Development Review Committee (DRC) Meeting

Tuesday, September 19th, 2023 – 9:30 AM

Subject Case # 23-06-FSP-Spincity Laundry

Subject Case # 22-03-PPR-DeBary Town Park

A2.1

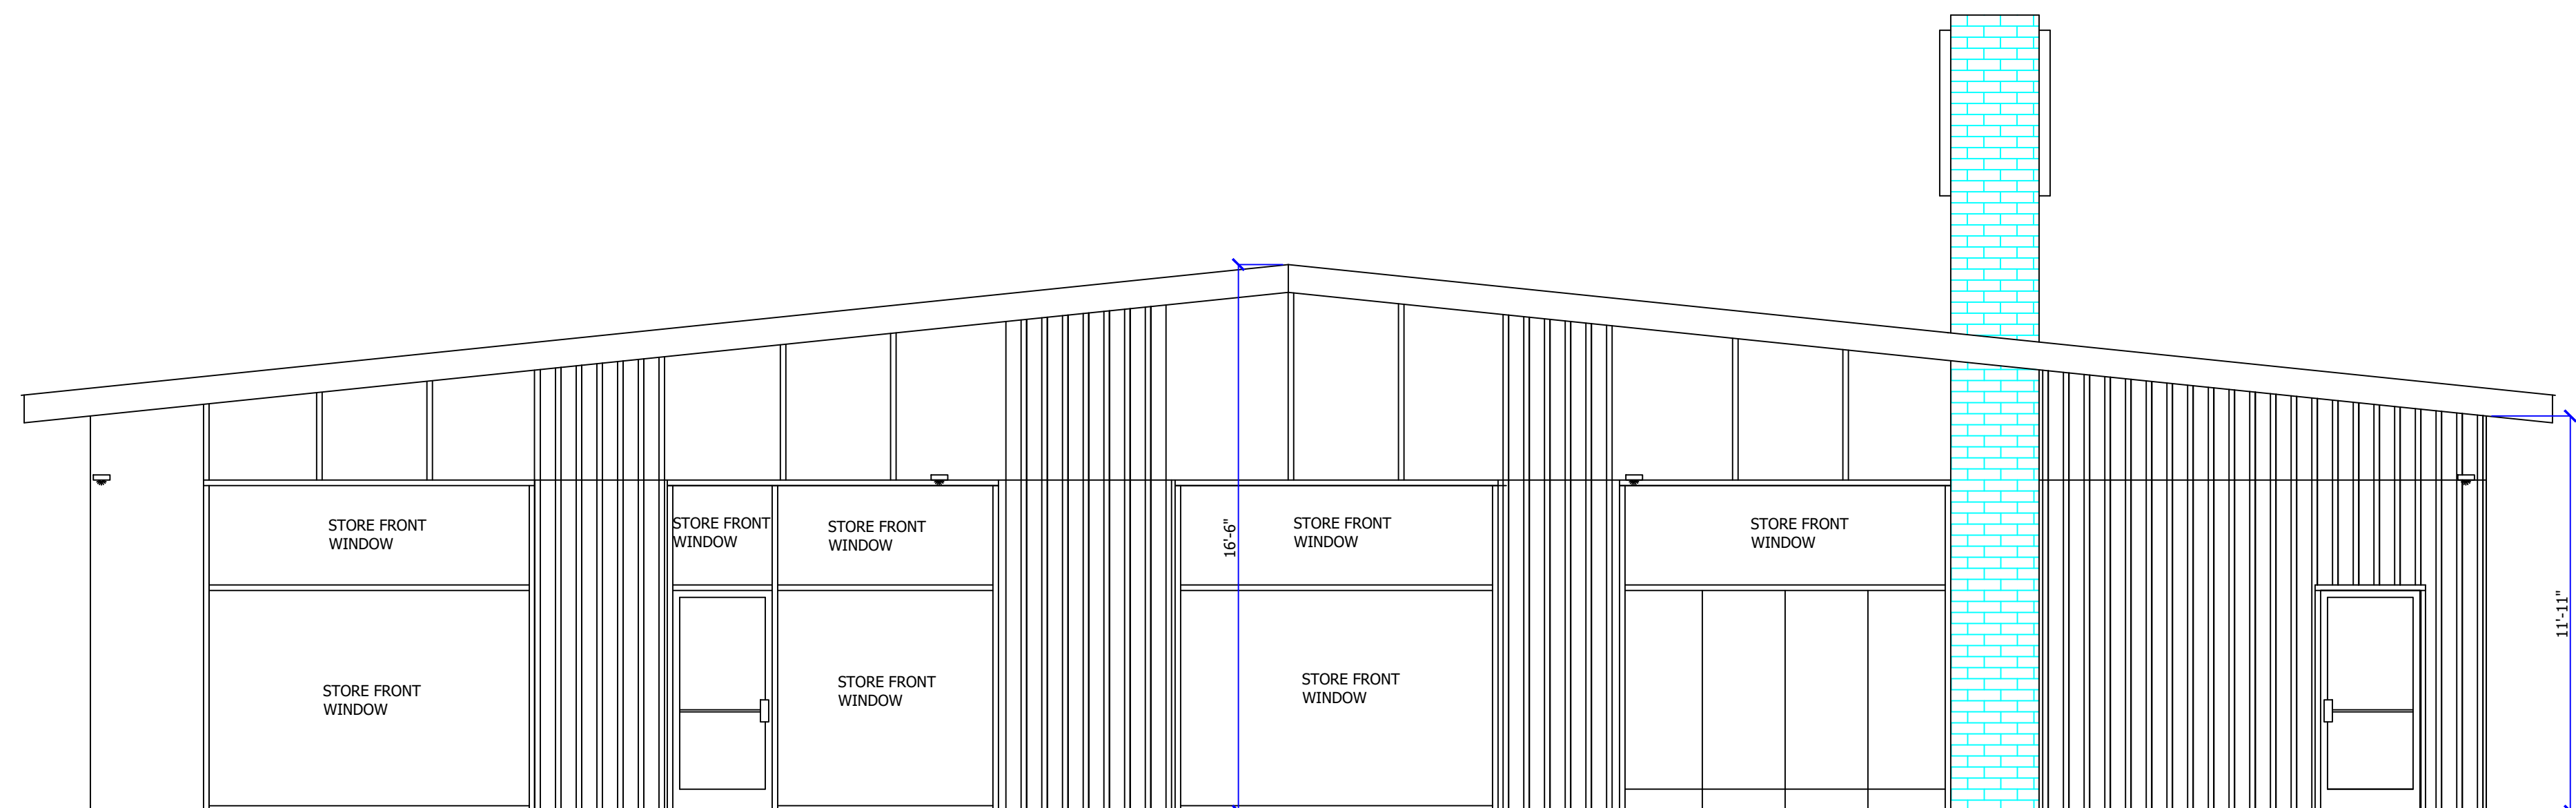
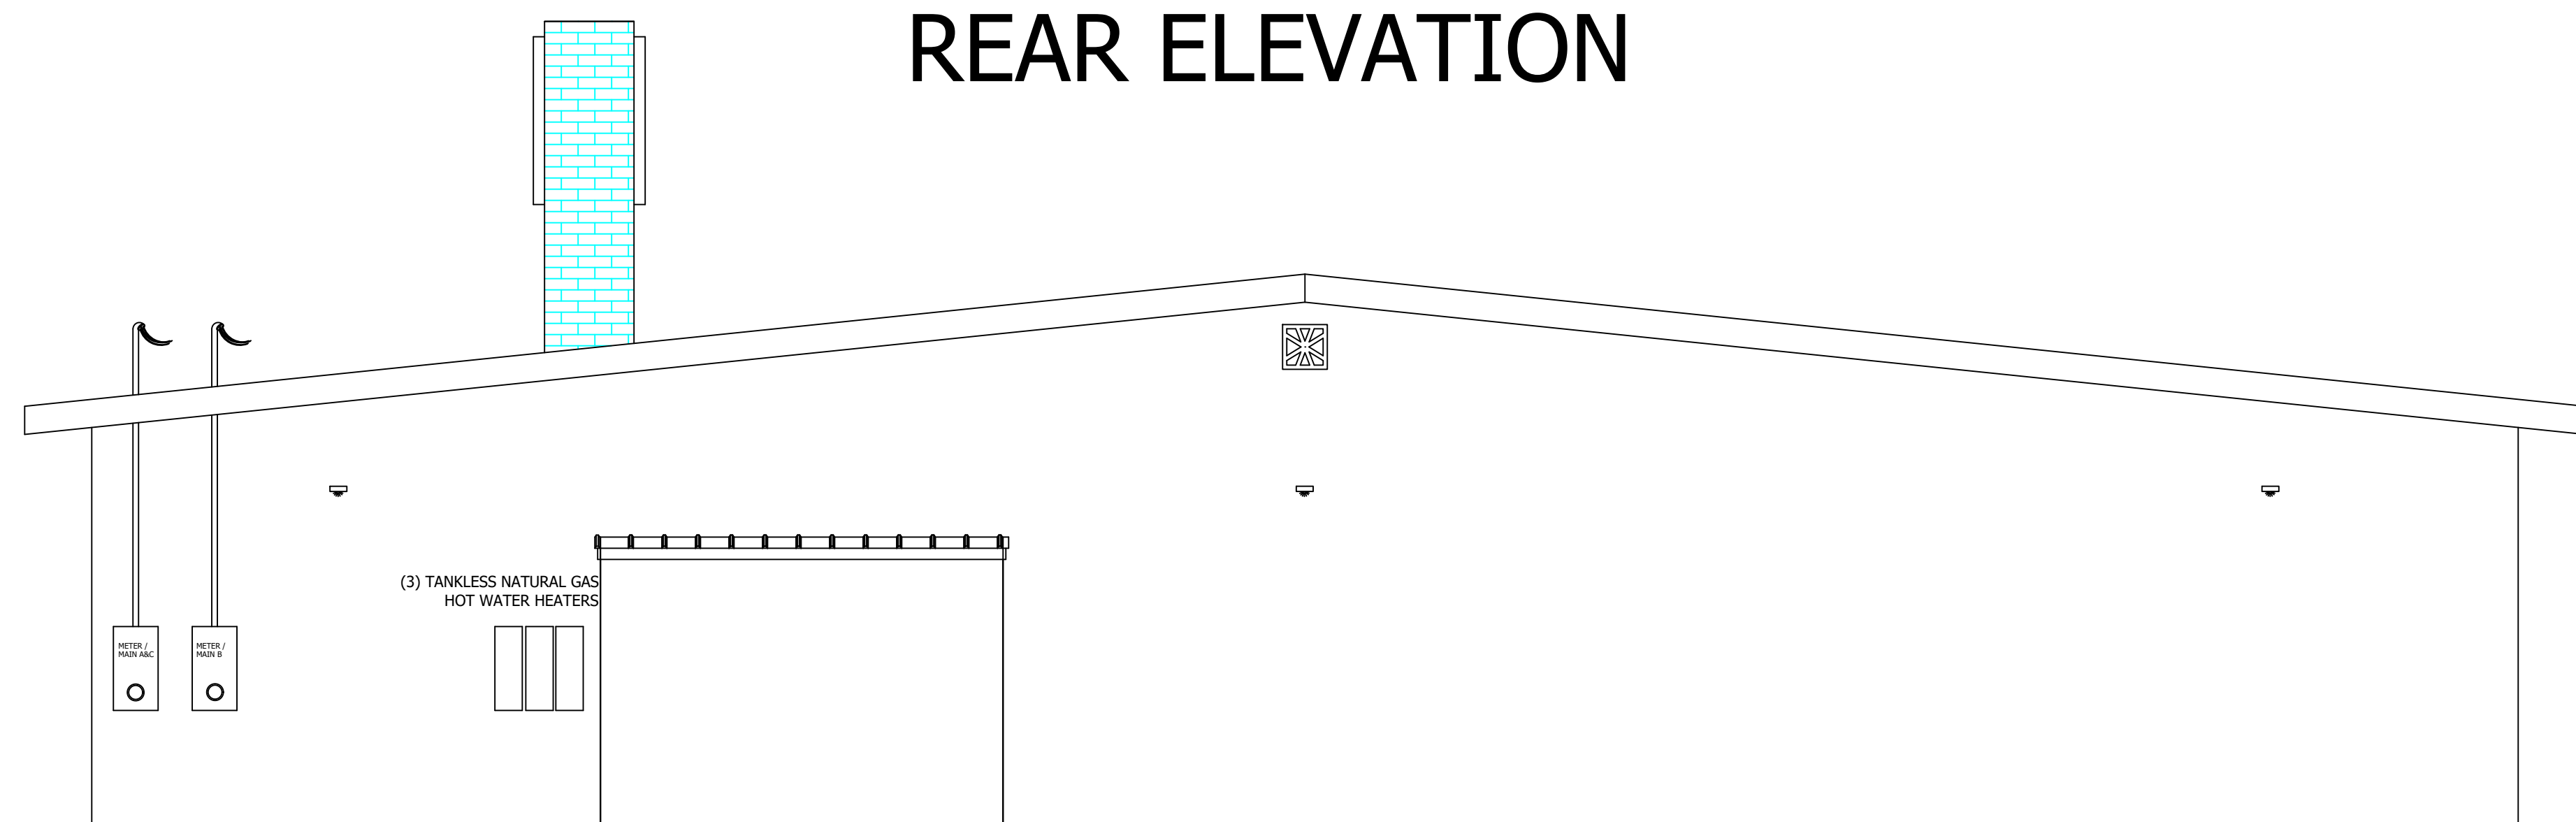
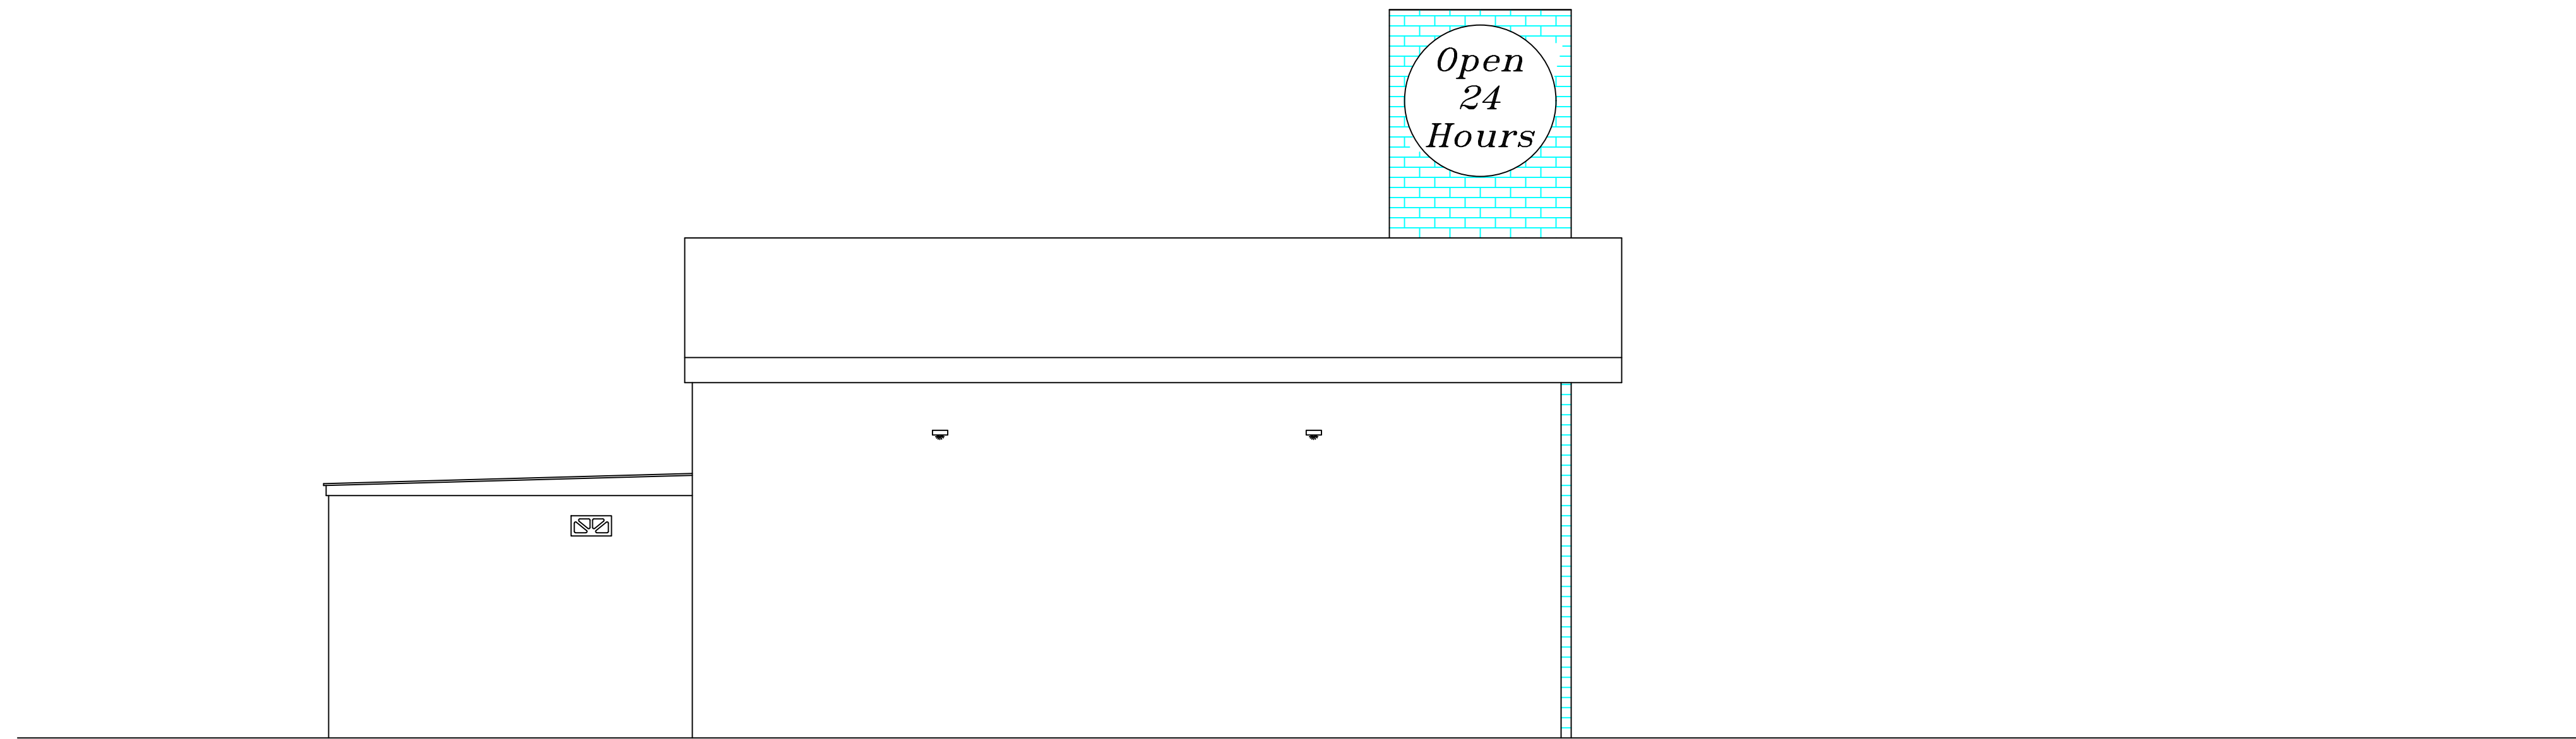
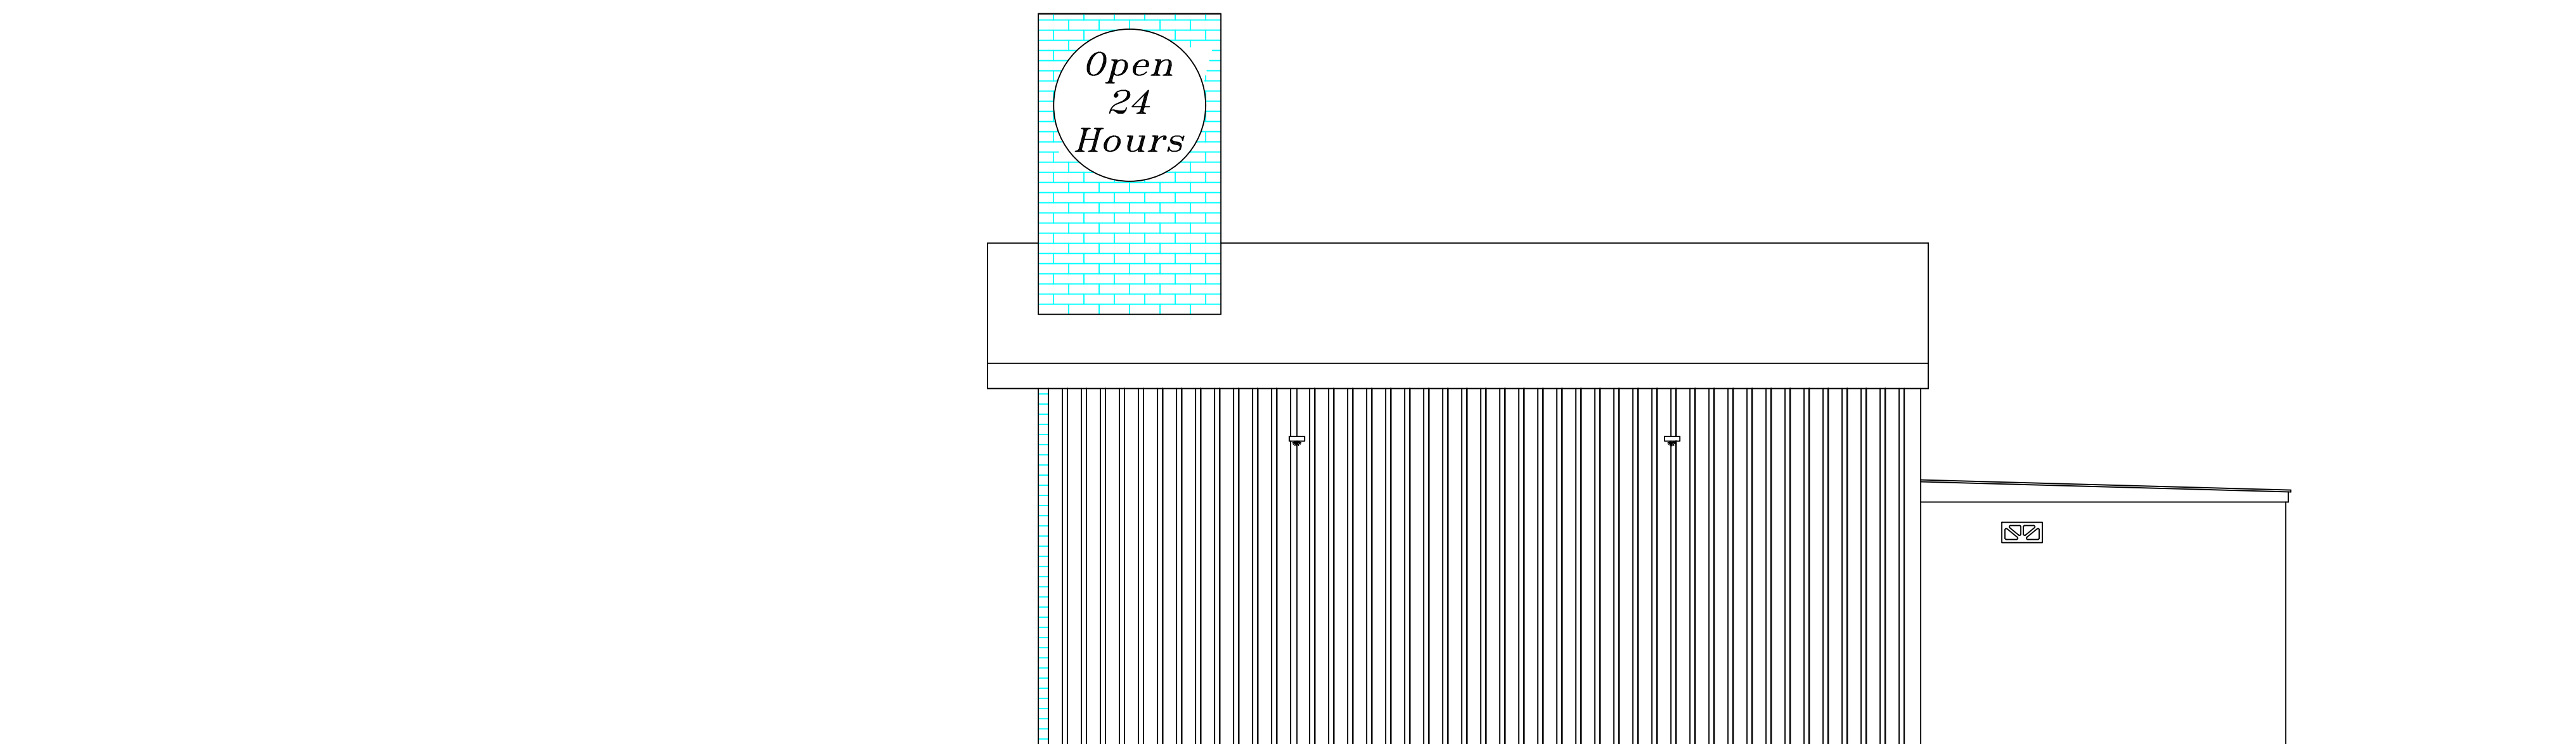
What is the material and color of the façade that is not window?

Will the entryway be differentiated from the remainder of the façade in compliance with Section 5-123(b)(5)a?

More detail on lighting will be necessary to confirm compliance with Section 5-123(b)(11).

During the plan review our plans showed exterior lighting the plans examiner returned page E1 to Planning and Zoning to have an additional look at the exterior lighting. After a second look Planning and Zoning determined it necessary for us to go in front of the DRC for their approval on exterior lighting. Planning and Zoning additionally asked for ADA compliant striping and any additional parking. Our survey depicts the request asked of us. Our updated lighting plan which can be found on E1.2 depicts perimeter lighting as well as a cut sheet of Model ESXF1 LED FLOODLIGHT. Located on the backside of the cut sheet shows the adjustable lumens and kelvins for the ESXF1 LED FLOODLIGHT. The ESXF1 LED FLOODLIGHTS have an adjustable mounting knuckle and can be mounted at any desired angle. Please note that the lumens and kelvins are BOTH individually adjustable. These lights will more than accommodate the existing city ordinance.

ALL EXTERIOR LIGHTING TO BE LITHONIA ESXF2 SWITCHABLE WHITE | ADJUSTABLE LUMINS | DUSK TO DAWN PHOTOCELL

PORCH PRINCIPLES

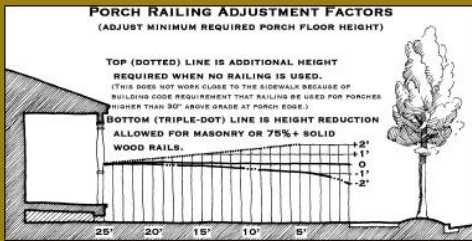
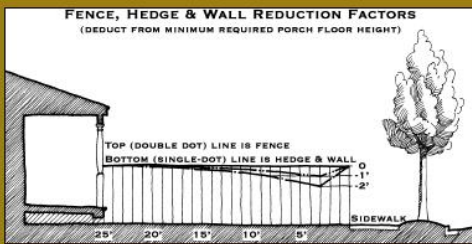
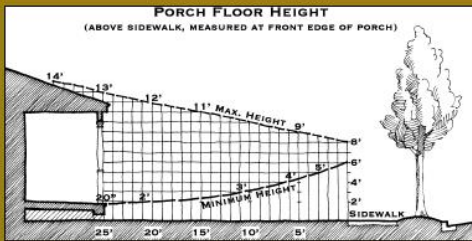
21. Finished floor levels to be raised based on distance from sidewalk.
